## Comments to Reviewer #1:

The topic of the paper (i.e. hazard in ephemeral streams) is of great interest and the comparison between two different streams is very helpful to better understand channel processes and making prediction on future channel dynamics. That said, I have several concerns about this work. My main points of concern are: (1) The overall quality of presentation is quite low; several parts are hard to follow and some parts could be more concise; (2) Overall the work is very descriptive, while several aspects could be presented and discussed by a quantitative approach. (3) What is the novelty of this work? I think that to conclude that “: : natural channels are much more adapted for floods than human modified sections: :” (page 23) is not new. The authors should be stressed more clearly the novelty of their work.

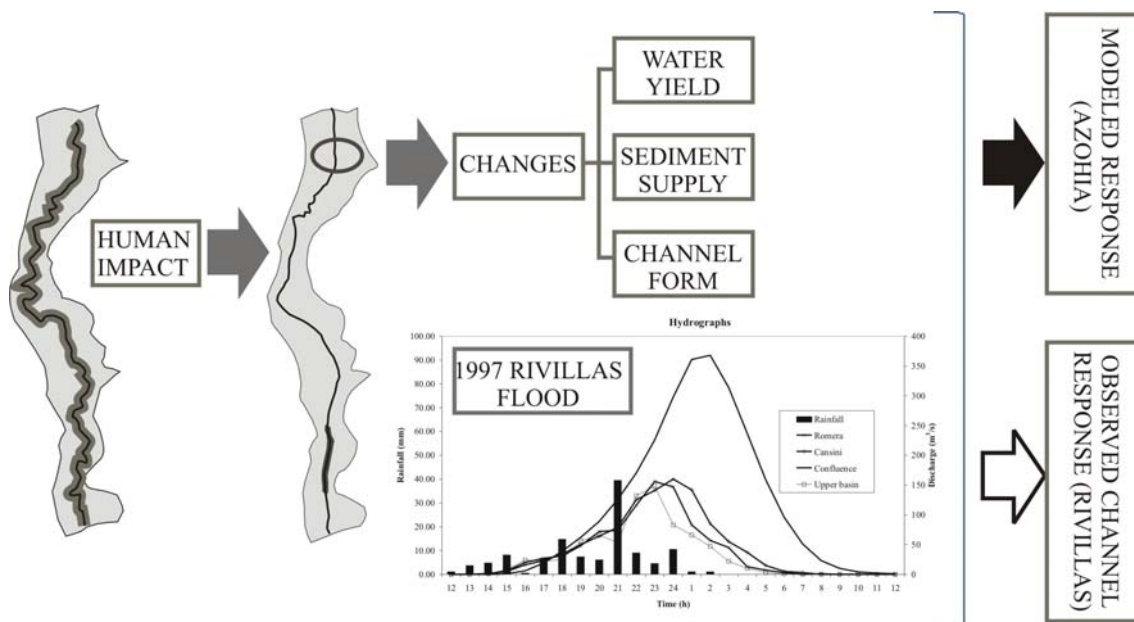
Figure 1. Meaning of “s” and “v” needs to be explained in the figure caption.

*The figure 1 text (s= sinuosity and V= vegetation cover, has been removed. This is not relevant for a conceptual model*

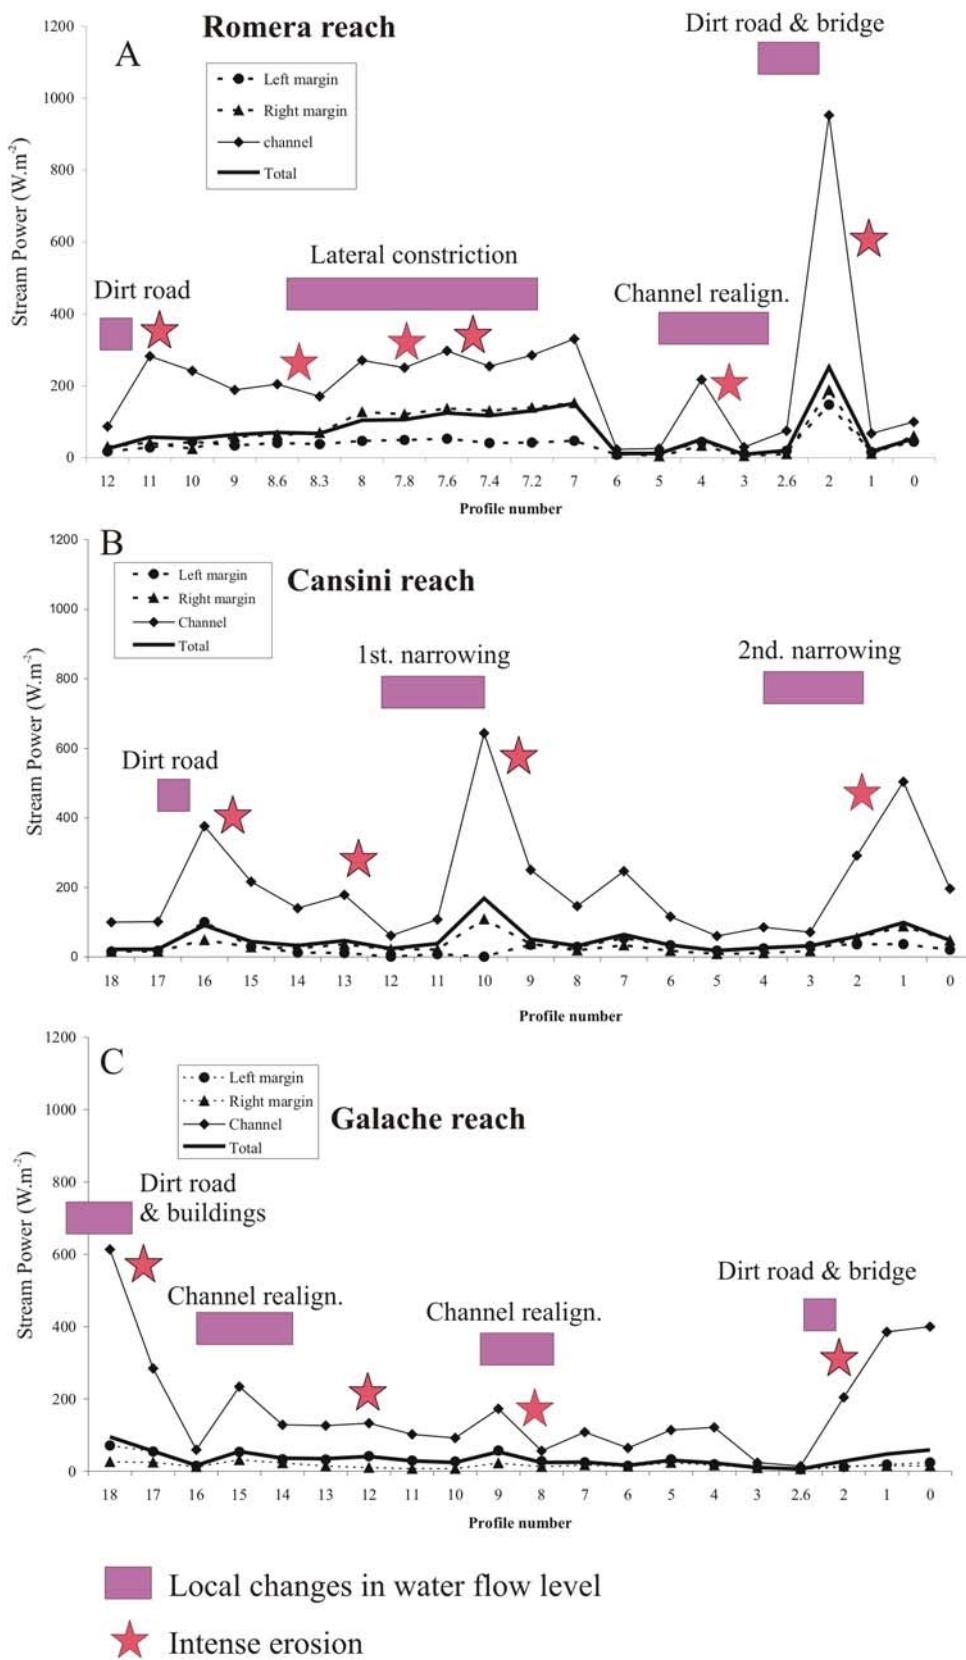
Figure 10. “Water flow disturbance” sounds as a strange term; could you find another term for this?

Figure 10. It should be explained the meaning of the different estimate of stream power (i.e. left margin, right margin, etc.).

Figure 10. Parameter used on "Y" axis should be "unit stream power"; in (a) and (c) should be "Wm-2 " instead of "Nm-2".

*We agree with the reviewer this term is confusing. We removed it and substitute with: “Local changes in water flow level”*

*We obtain values of stream power from the model HEC-ras, which provides this information separately in channel, left and right margin. We think this information should be important to understand where the energy is located during a flood event.*

*We rephrased the sentence in the new manuscript as here we present: "Figure 10 shows the stream power separately in channel, left and right margin. This can point out where energy is concentrated during a flood. In the same figure the areas where erosion has been intense and major anthropic modifications capable of generating changes in river behavior during the flood are shown ..."*

*This has been done (see figure above).*

Fig. 2. Map location of the two studied areas, (a) Rivillas watershed and geological map, (b) Azohia watershed and geological map.

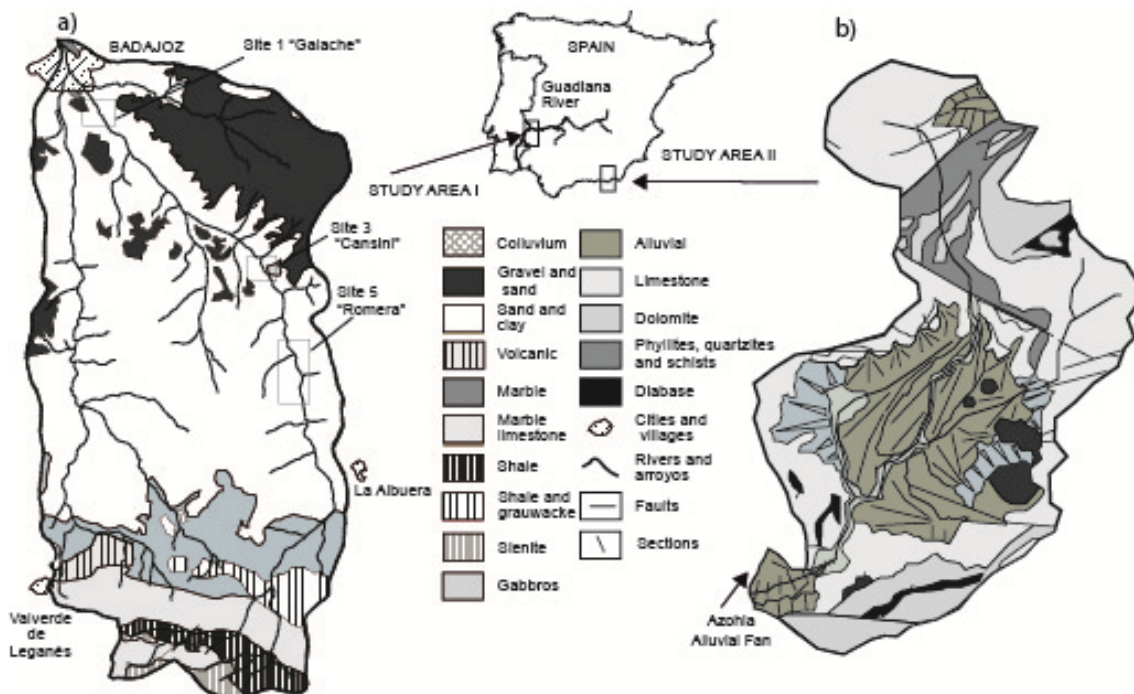
Figure 2:

All suggestions has been done (see figure)
